Fujian Shun Chang Yangkou Hydro Power Co., Ltd.
5F MoDian Building, Shunchang County,
Fujian353200, China
Tel: +86-599-7858-766 Fax: +86-599-7858-955

**Request for review –Shunchang Yangkou Hydro Power Project, Fujian, China
(Project No.: 2008)**

Please find below our responses to the issues raised as part of the request for review for this project.

Table 3 Variation of IRR to the parameters alteration

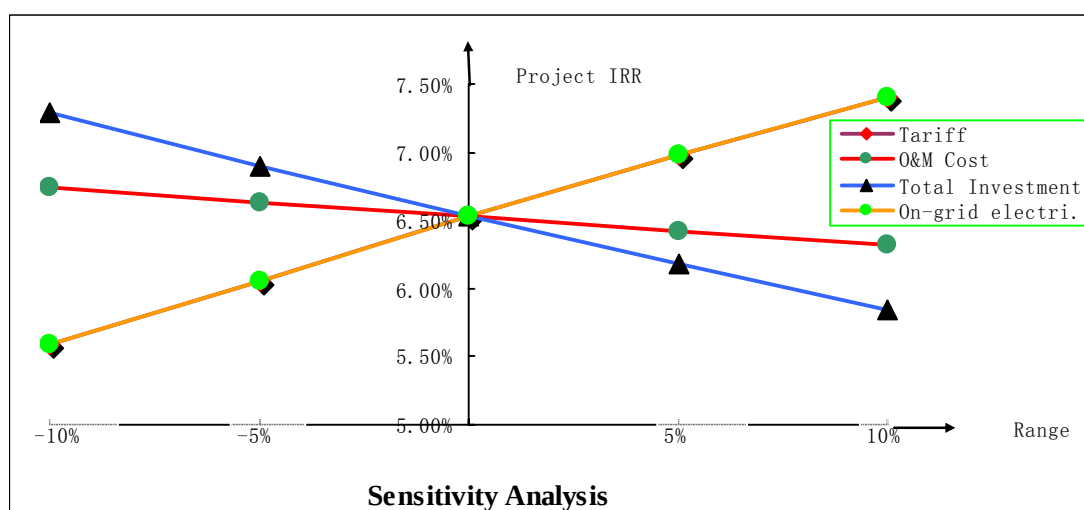
2. The DOE should explain how it has validated the sensitivity analysis, in particular: (a) why the PLF has not been included in the analysis; and (b) that the IRR is not likely to cross the benchmark.

- (a) The PLF should be included in the sensitivity analysis by on-grid electricity. The new revision is as below and PDD has been revised accordingly.

Plant Load Factor(PLF) multiply by 8,760 hours is operation hours. And operation hours multiply by installed capacity is on-grid electricity. As installed capacity is a constant,so the variation of PLF will be indicated on on-grid electricity, vice-versa. The revision sensitivity analysis including parameter of on-grid electricity is showed on table 3 below.
